Project: Provincial Fire and Life Safety Project - Baldur District Hospital and Personal Care Home

ADDENDUM 03

Project:	Provincial Fire Life Safety – Baldur District HC & PCH
Commission Number:	21569.52 SMS Project No.: 24-001-05 / 26-001-12
Date:	Nov 19, 2025
Pages:	2 + 9 attachments + 1 sheet

Project Title
PROVINCIAL FIRE AND LIFE
SAFETY PROJECT
BALDUR DISTRICT PCH & HC

NOTES

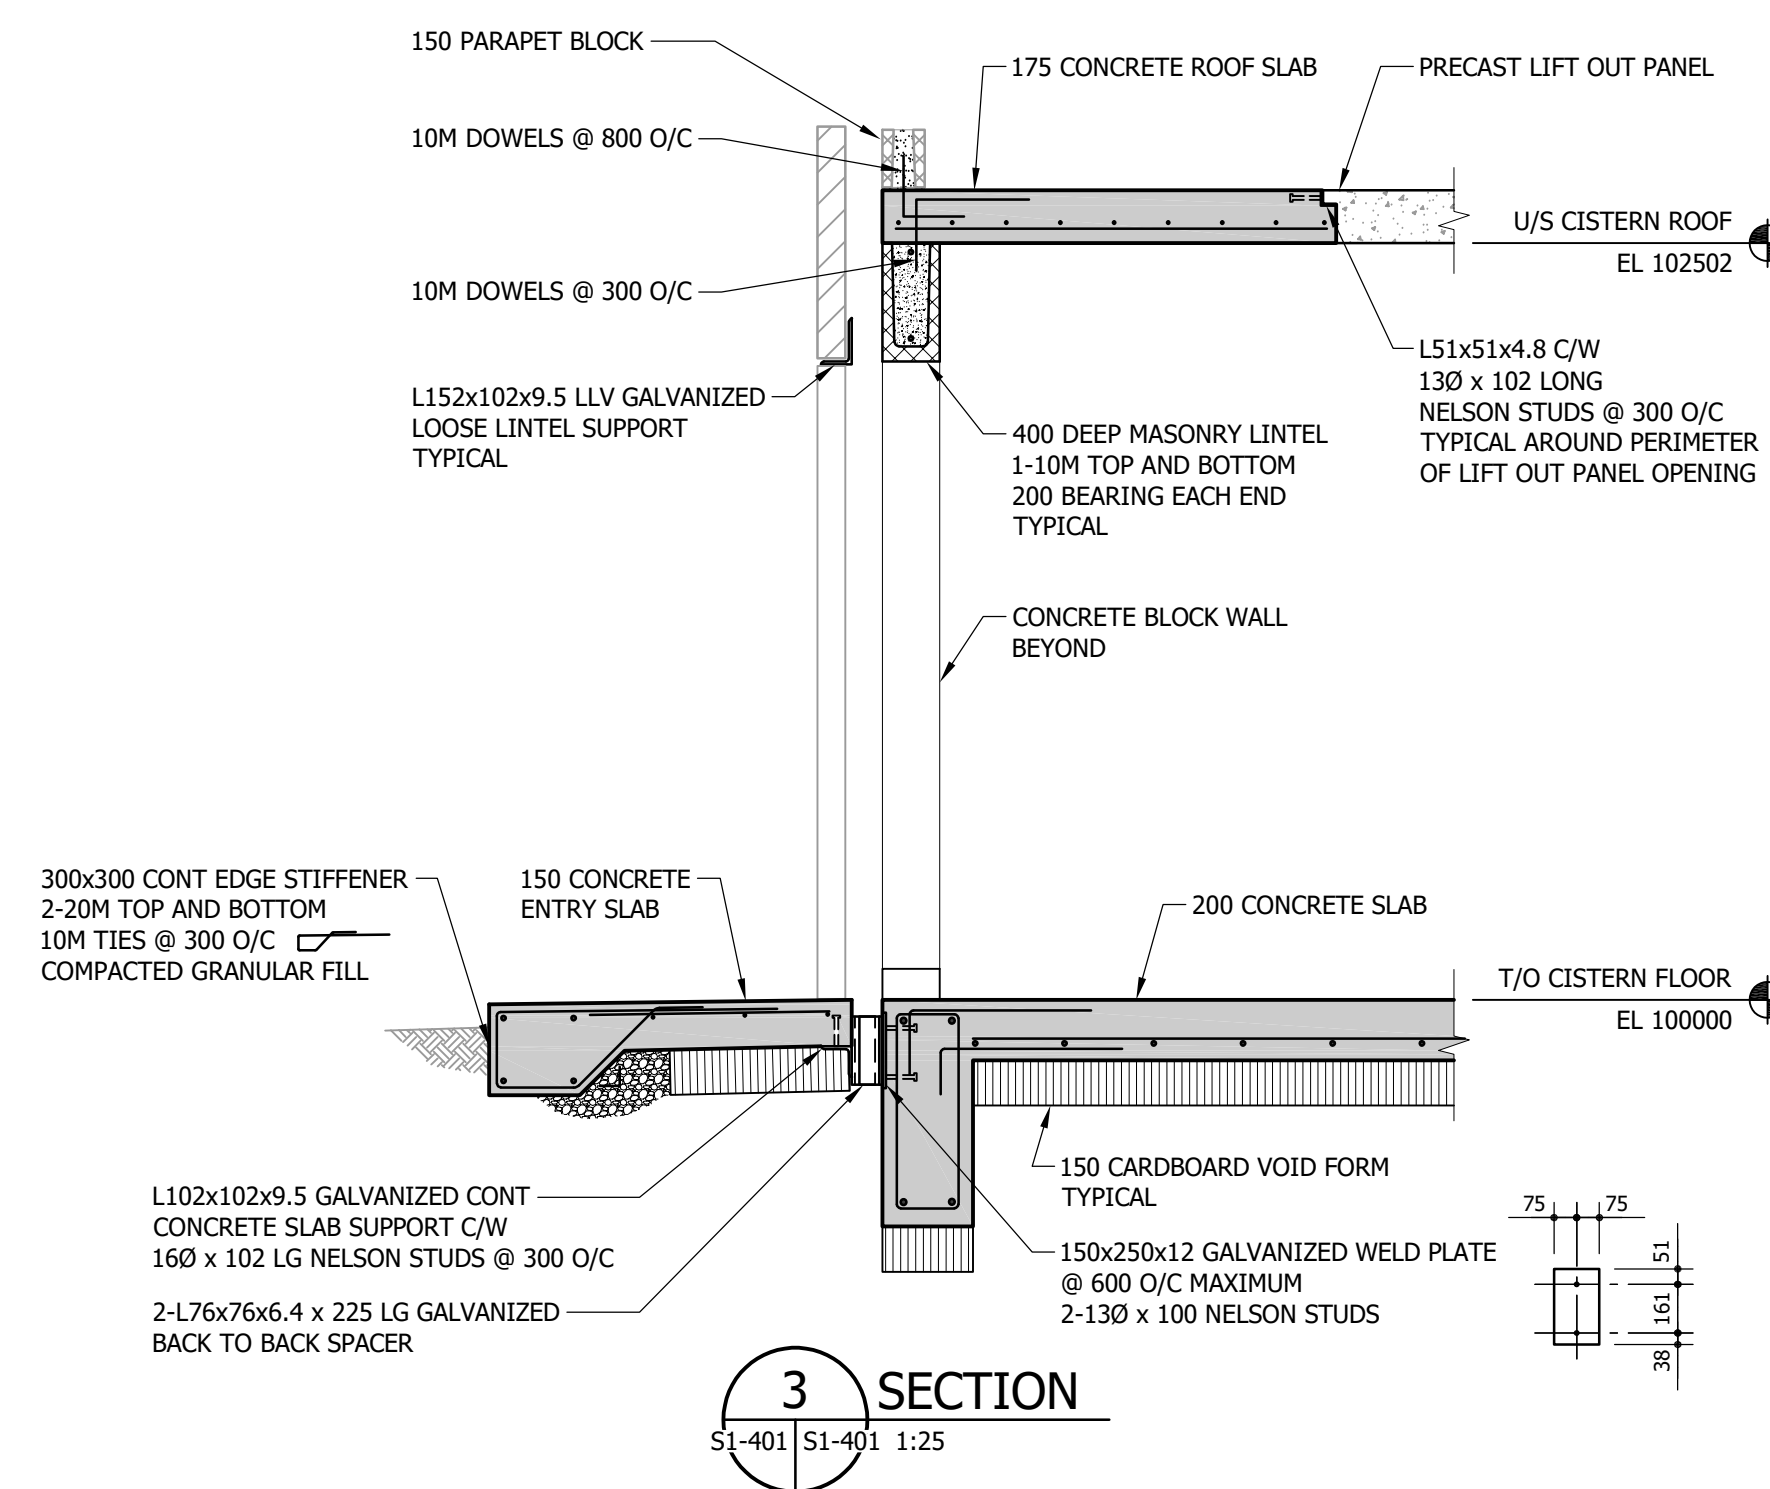
Question: On drawing S1-401: detail section 1, can the beams be poured first and then the floor slab with the curb second?

Refer to S1-401 (attached). Decreased size of Fire Pump House on S1-401 to match Architectural and Mechanical drawings.

Answer: Yes, the beams and slabs can be poured separately, minimum 40mm deep construction joint key is required as per the structural general notes.
